Subject: Bishop Tube Public Comment

**Comments on the Bishop Tube Site 8/17/2021
Analysis of Alternatives and Proposed Response**

I write to provide comments on the *Remedial Investigation Report* (RIR) and *Feasibility Study Report* (FSR) regarding the Former Bishop Tube Property, East Whiteland Township, Chester County, Pennsylvania, authored by Roux Associates, Inc. (2019a and 2019b). As you will read, I find that the analyses presented in the RIR are deficient in several respects; and I offer suggestions for improving upon these analyses. Because the FSR is based on the RIR, it too is unreliable.

Roux Associates (Roux) completed a Remedial Investigation Report (RIR) and Feasibility Study (FS) for the Bishop Tube (BT) site in 2021¹, which were updates to 2019 versions. The FS identifies potential remedial activities, as identified by Roux. A FS Addendum supplemented the FS report. In August 2021, the Pennsylvania Department of Environmental Protection (DEP) issued its Analysis of Alternatives and Proposed Response (AOA) in which it chooses its remediation plans for the BT site. The memorandum reviews that choice and DEP's reasoning.

Figure 1 Comparison of sampling in MW-23 and MW-06

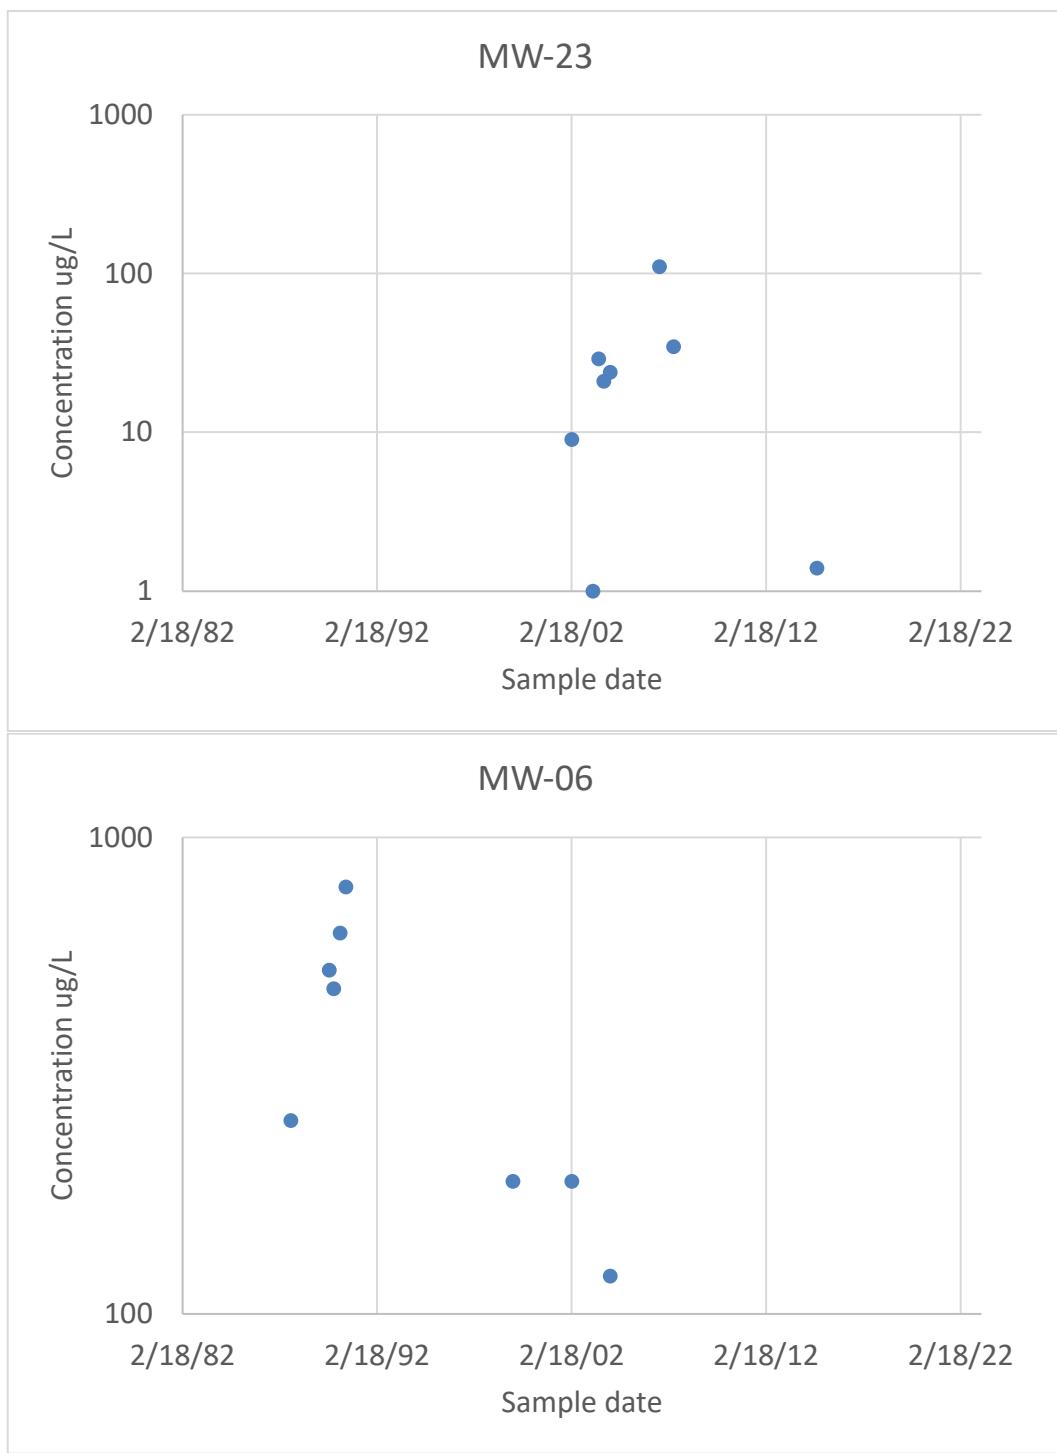
- c. It is difficult to conceive of any consistent specification that would include MW-23 but exclude MW-06, as is done in the RIR (see Figure 1).
 - d. The methodology adopted in the RIR was to average the “half-lives” calculated by linear regression over all available measurements in Table B-1 for the wells in Table 2 of Appendix S. This methodology is incorrect, however, for at least two reasons. First, if such averaging over wells were appropriate, then the correct methodology requires averaging over all “decay rates” (both positive and negative), not averaging over “half-lives” (essentially the inverse of “decay rates”). Second, performing such averaging assumes that the average has some physical meaning — that the “decay rate” measurements in individual wells are all (imperfect) measures of the same quantity applicable to the whole site — but in this case, examination of the distribution of “decay rates” shows that the measurements are in fact not of the same quantity. Figure 2 shows a normal probability plot of the “decay rate” (λ) for all 51 monitoring wells satisfying the first criterion (≥ 4 points, ≥ 4 years). This distribution is indistinguishable from normal,⁵ and clearly the measurements are not all consistent with a single mean value. A formal likelihood ratio test confirms this — maximum likelihood estimates of mean and standard deviation of a normal distribution are 0.00029 per day and 0.00024 per day respectively, taking account of all the individual uncertainties, and the standard deviation estimate is non-zero ($p = 1e-97$).

Figure 2 Normal probability plot of “decay rates” in the 51 monitoring wells, with standard errors

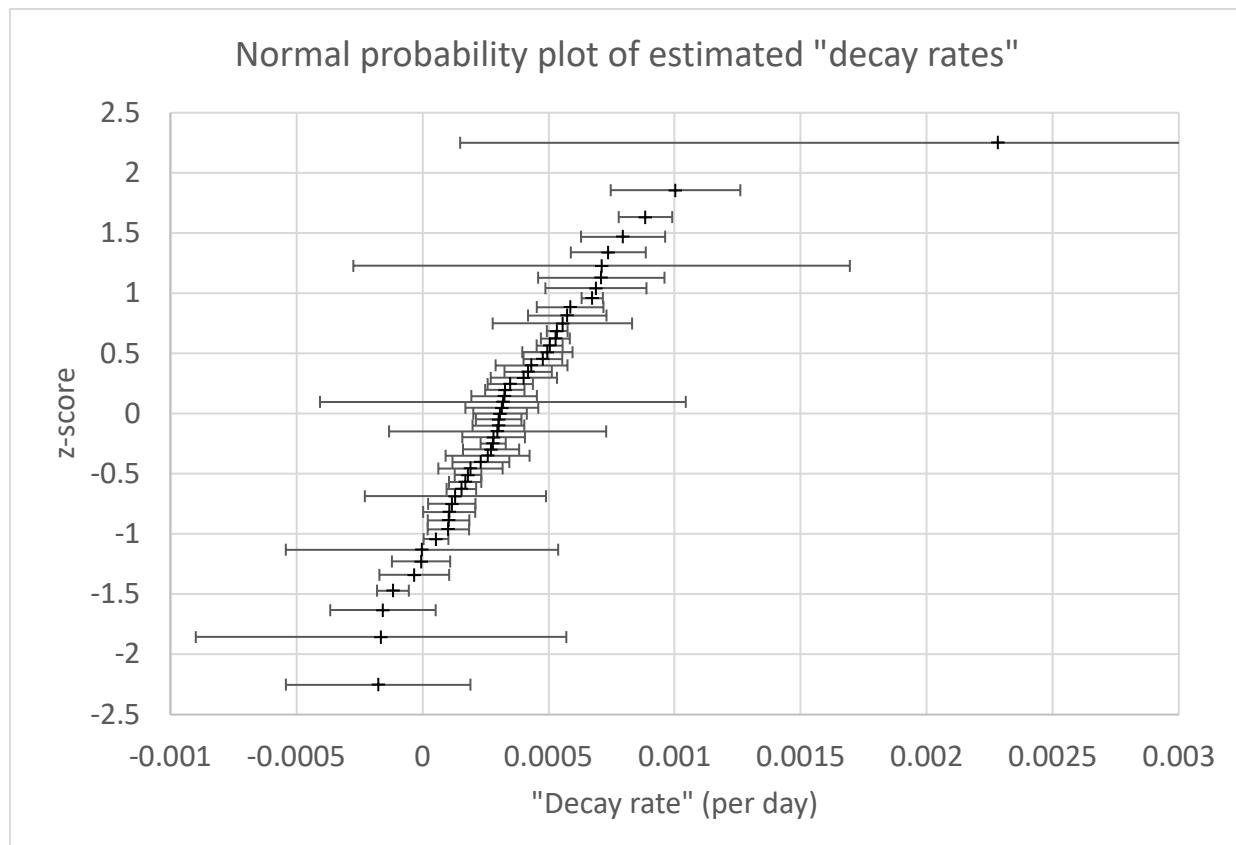
The implication of the non-zero standard deviation is that the “half-life” varies in different places on the site. This variation (if the methodology used to derive the value had any meaning; but see above and below) would need to be taken into account in any modeling. Indeed, approximately one third or more of the “half-life” measurements are consistent *with no “decay” at all* that those locations (see Figure 2). This conclusion is not surprising, given the results shown below, since the concentration at any particular well can be increasing, decreasing, or constant, dependent on multiple factors of which TCE degradation is only one. And in view of the microcosm tests (Baker, 2009, Appendix A; Roux, 2015a, Appendix B), such a finding for actual TCE degradation rates would also not be surprising; and such degradation rates remain to be measured, particularly any variation of half-life with depth and/or location.

Figure 3 Measured concentrations, the RIR “fit” to those concentrations, and a fit to those after 1995, and the modeled concentration in MW-15, with a line showing the assumed decay rate.

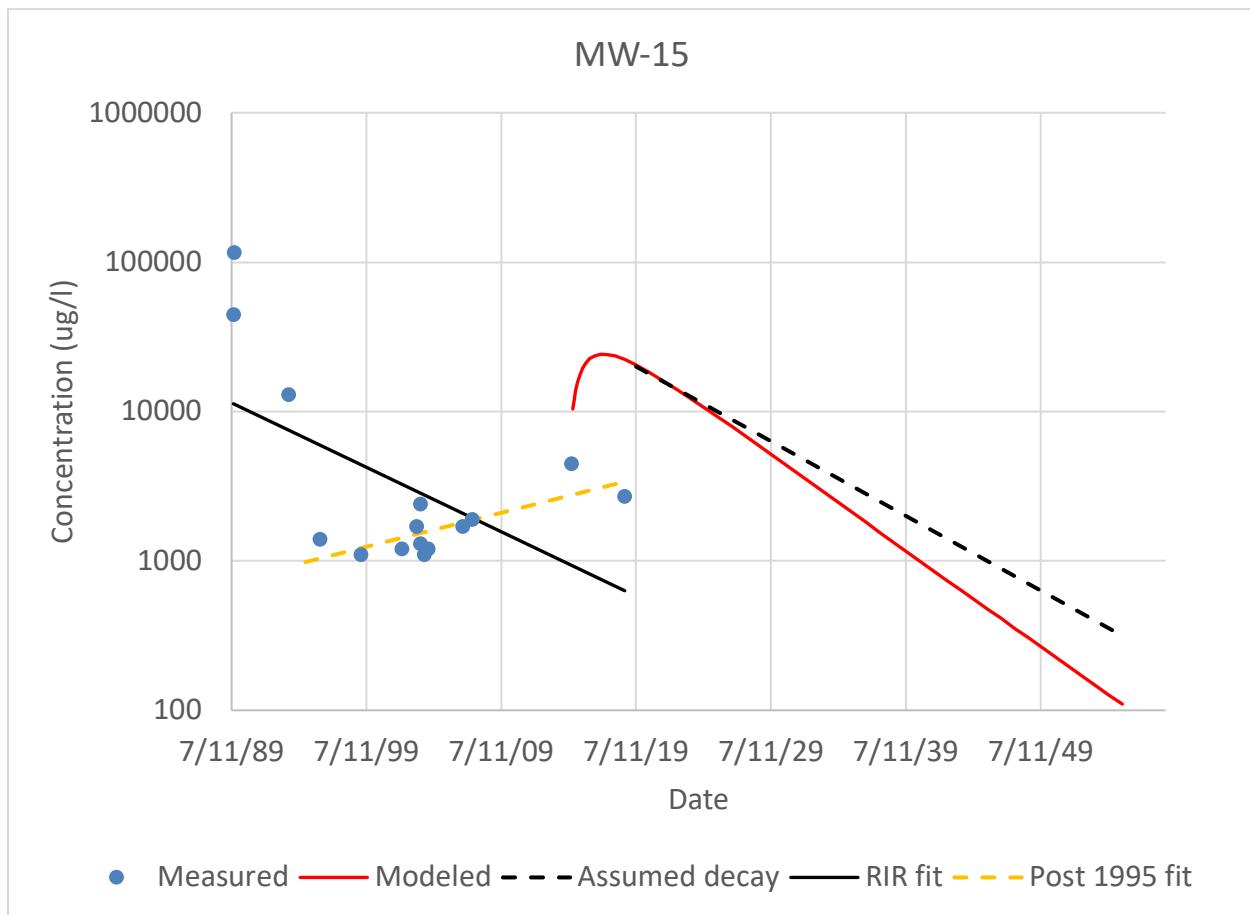
There are some wells in which variations in source strength are much more likely than decay to account for a major part of some concentration variations. Several wells have a very substantial decrease in concentration between measurements made prior to the mid 1990s and those made subsequent to that time. Particular examples in which decay as the only determinant of substantial reductions occurring between the 1980 to early 1990s and early 2000s seems unlikely are MW-15 (Figure 3) and MW-03 (Figure 4), with less obvious examples being MW-02 (Figure 5), MW-06 (Figure 6), and MW-08 (Figure 7), although such an effect cannot be ruled out in *any* well without adequate analysis that takes account of the propagation time and dispersion occurring between source and well. The example wells mentioned here are close to the putative source(s) of the TCE, so would reflect changes in source terms relatively soon after such source changes, and the changes would not be substantially extended in time by dispersion. The effect of source changes in wells further downgradient would occur later and be slower. Since the source term probably ceased sometime in the 1980s or as late as 1991, abrupt changes in nearby wells between the 1980s and late 1990s may quite plausibly be due to source changes.

Figure 3 (MW-15) also illustrates the disconnect between measured concentrations and the RIR modeling, for this well at least. The initial peak in the modeling is due to a higher concentration part of the plume passing by MW-15, and the faster drop-off in concentration at large times (compared with the decay rate, illustrated by the dashed black line) is due to the reducing concentration behind that higher concentration part of the plume (MW-15 is situated so that, in the modeling, a kink in the assumed 10,000 µg/L contour will sweep across it as the whole plume migrates down-gradient; see Figure 46 of the RIR).

Figure 8 The absolute worst-case estimate of plume centerline concentration using the RIR model.

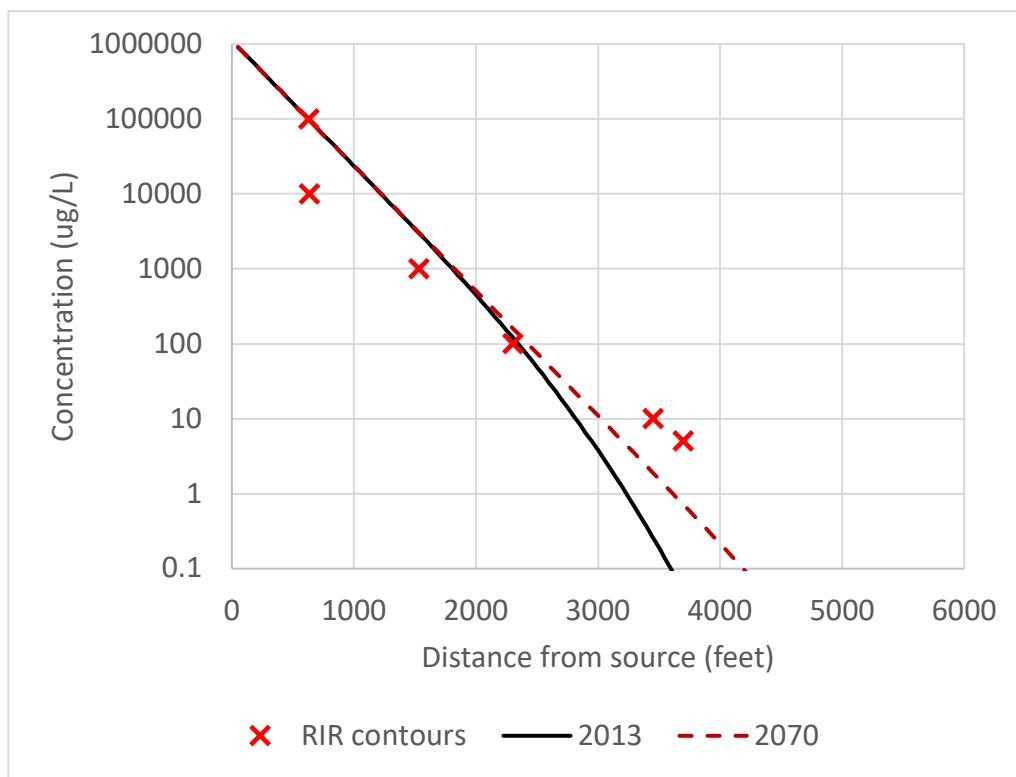
Clearly, with the parameter values used in the RIR, this worst-case plume would be in steady state out to 2,000 feet in 2013, and out to beyond 4,000 ft by 2070, and the 5 µg/L contour would never extend beyond about 3,200 feet.

Figure 9 Showing that a constant source can match the RIR results with just a change in hydraulic conductivity.

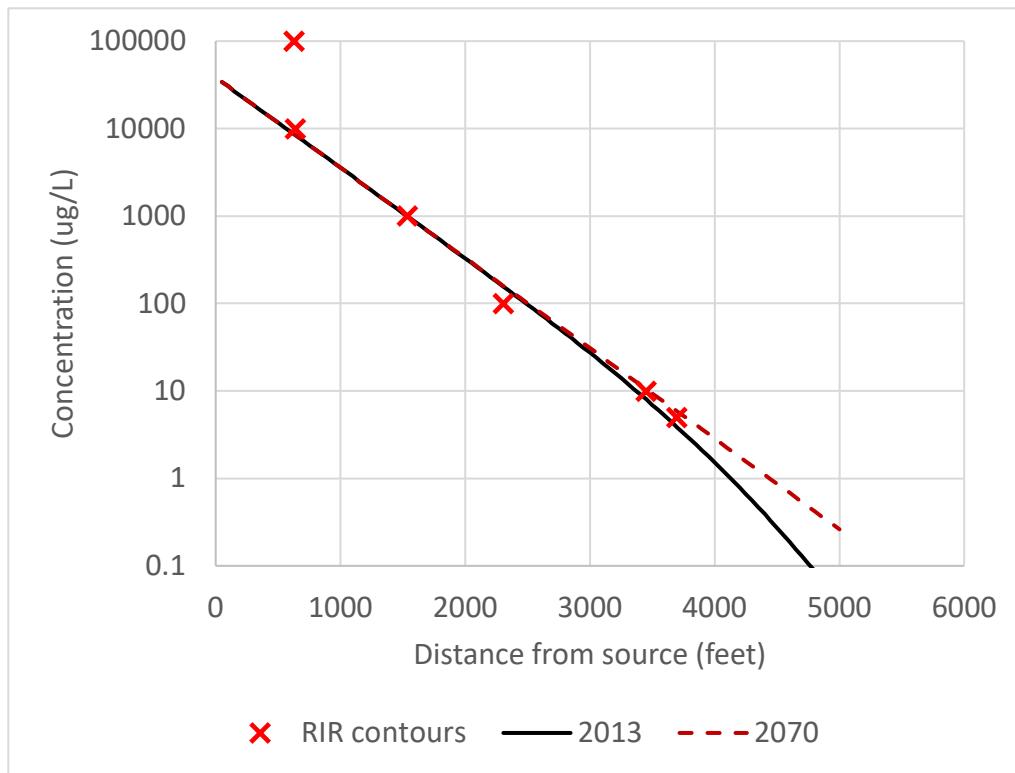
It is, however, not difficult to find parameter estimates within the range discussed in the RIR or in previous modeling (Baker, 2004), that allow matching the plume estimates of RIR Figure 46, at least beyond the 100,000 µg/L contour. I consider that contour to simply reflect the anisotropy of the subsurface, with insufficient distance from the source(s) for the averaging effect of dispersion to have had sufficient effect for any smooth model to match it. For

example, simply increasing the estimated hydraulic conductivity to 2.129 ft/day and reducing the assumed (constant forever after 1951) source term gives Figure 9, which shows a plume in practical equilibrium to about 2,500 ft by 2013, and beyond 5,000 feet in 2070.

Figure 10 An example showing that the RIR might have substantially underestimated potential plume extent; and the effect of an immediate source term cleanup.

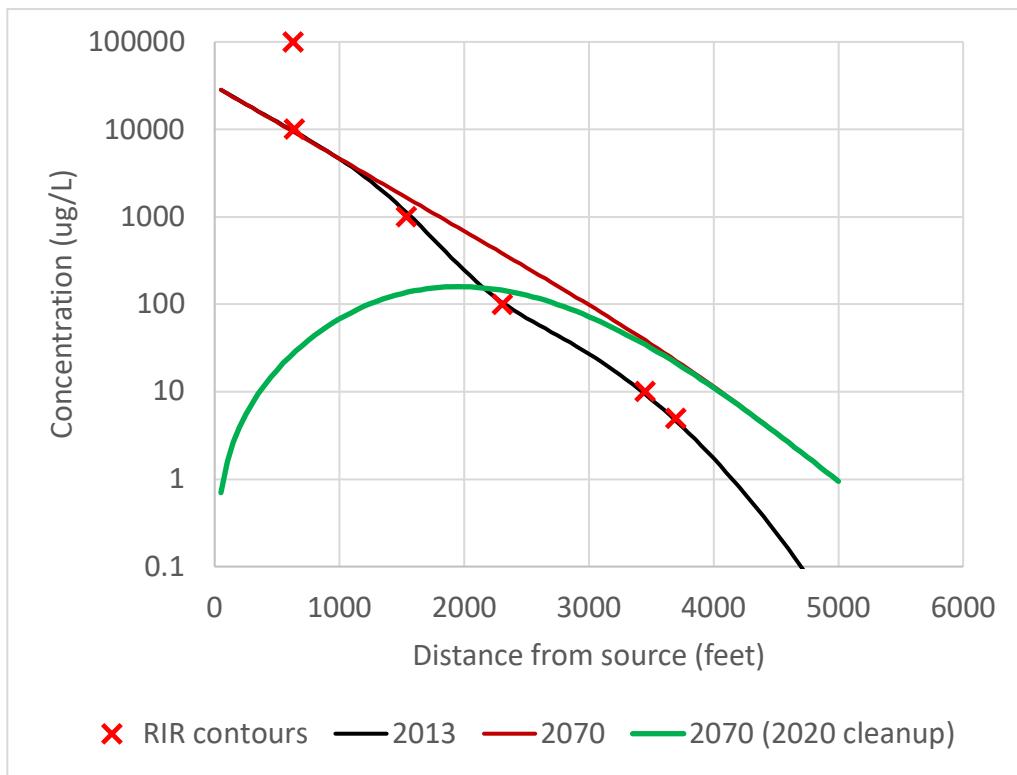
However, while it is possible to find combinations of parameters agreeing with the RIR conclusions, it is also possible to find combinations that disagree substantially. Thus Figure 10 shows an example with variable source term that matches the RIR estimated plume in 2013, but demonstrates that the plume might extend considerably further by 2070 (indeed, in this case, the 5 $\mu\text{g}/\text{L}$ contour would extend to approximately 4,500 ft by about 2100). This particular solution corresponds to a hydraulic conductivity of 1.776 ft/day and a degradation half-life of 3,506 days,⁹ which are fully as plausible as the values used in the RIR and are “calibrated” to the observed plume in 2013.¹⁰

Also shown on Figure 10 is the effect of stopping the entire source completely in 2020, to illustrate the importance of immediate action. The hypothetical source term was selected so that, in 1991, 70% of the source at that time was removed in an effort to illustrate the potential effect of stopping TCE releases at the site at that time. Any DNAPL TCE in the bedrock at that time would sink to deeper levels, with some presumably remaining trapped in blind pockets throughout the rock column. Gradual dissolution of both sources would probably provide a substantially reduced source strength compared with DNAPL TCE still flowing through the rock column. However, TCE present as DNAPL in or adsorbed to soil above the rock column would not be so affected by such a change — that would still be available for leaching into groundwater. Unfortunately, the RIR makes no attempt to evaluate the relative sizes of these sources, but merely assumes that both vanish entirely — the TCE in the rock column by implicit omission, and the TCE in the soil by simply assuming it away. Figure 10 arbitrarily assumes that the rock column is a negligible source after 1991, and that leaching from the soil could amount to 30% of the total at that time (and could continue forever). Removing the soil in 2020 would then correspond to the green curve, showing a substantial reduction in concentrations over the first 3,000 ft of plume by 2070.¹¹

Figure 11 Concentration versus time at various distances for the example in Figure 10

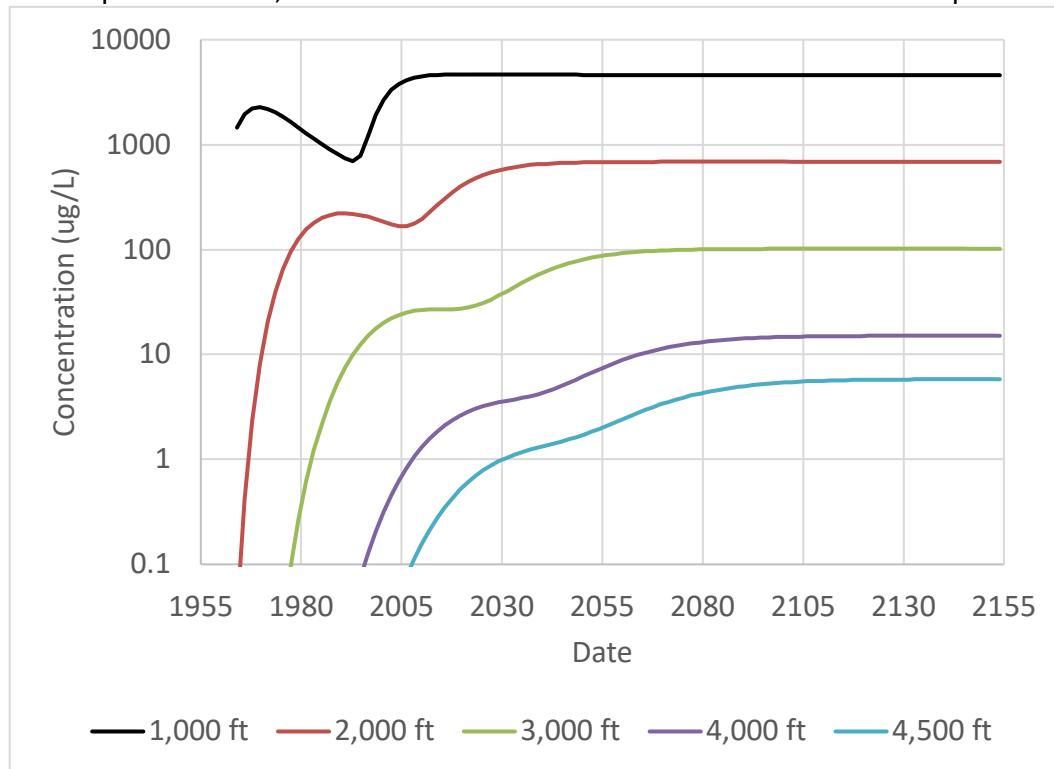
Concentration versus date curves at various down-gradient distances for the example shown in Figure 10 are shown in Figure 11. Noteworthy features include:

This example is probably not entirely compatible with all the measurements in individual wells at the site, although short term fluctuations in source term (not included here) could provide better correlations with such measurements while retaining the overall average effect. It is included to illustrate the potential effect of variations in source term. An adequate RIR would investigate the inverse problem of estimating the source terms from the well measurements, and obtain a consistent solution that would allow accurate estimates of the future plume.

Figure 12 Concentration versus date curves at various distances for the clean-up scenario in Figure 10

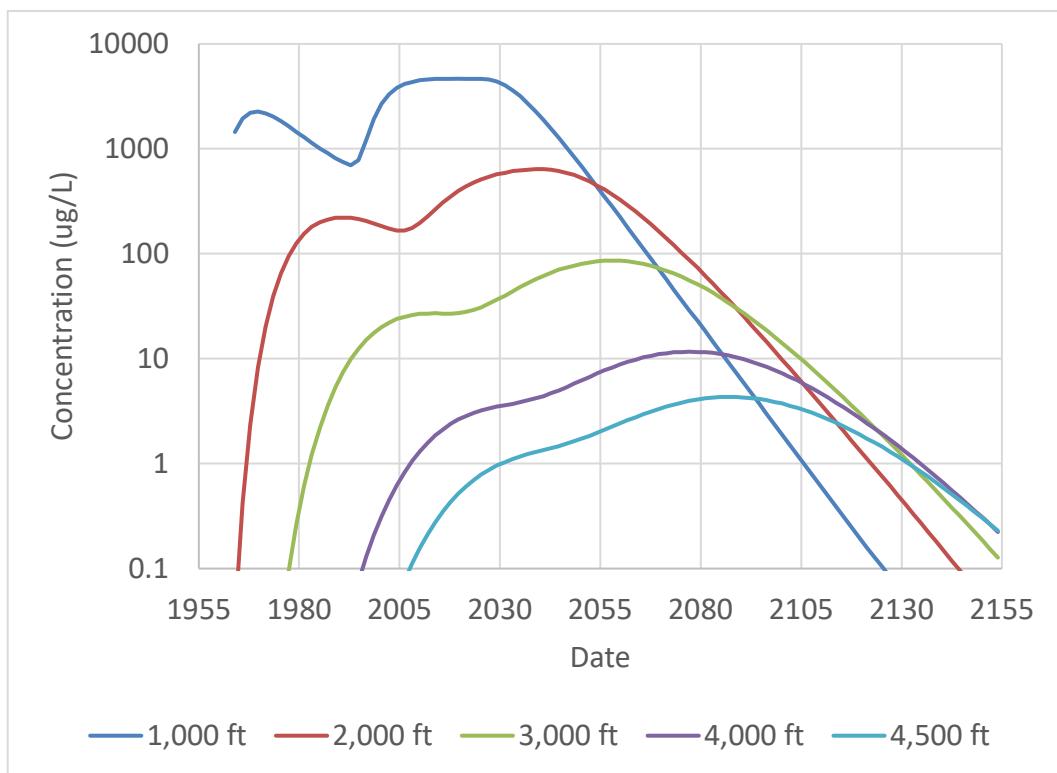
The concentration versus date curves corresponding to the cleanup scenario of Figure 10 are shown in Figure 12. Further noteworthy (and generic) features (compared with Figure 11) are:

- After a time delay corresponding to the propagation time from the source, the concentrations start to decline almost exponentially with time.
- Despite the appearance on Figure 12 that the declining curves could be parallel and straight, the exponential declines are different at different times and distances, and none of them correspond to the TCE degradation half-life (they are more rapid).
